HELMET

Appl'n No: 10/614,995

ANNOTATED
MARKED UP DRAWINGS

FIG. 3

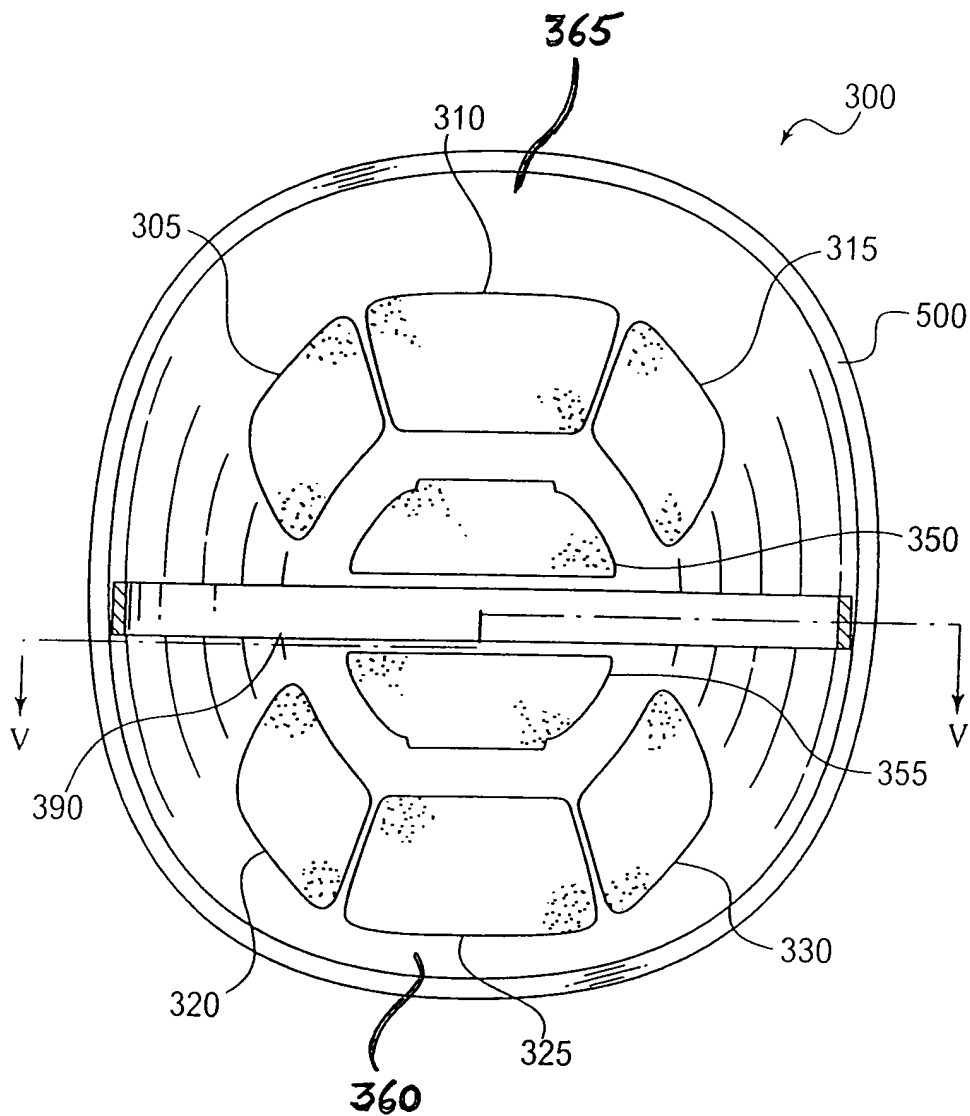
Figures 3 and 5 have been amended, in red ink, and are attached to this amendment for the Examiner's approval. In particular, applicant has added reference numerals to the corresponding Figures to describe existing portions of the helmet and pad set of the invention. No new matter has been introduced by the amendment.

Applicant submits herewith some specification corrections in response to the Examiner's objection to the same. In addition, some amendments to Figures 3 and 5 in support of the specification amendments have also been made, in red ink, for the Examiner's review. Applicant submits replacement sheets of drawings with the proposed changes as an appendix to this response. No new matter has been added by these amendments. Accordingly, reconsideration of the rejection is respectfully requested.
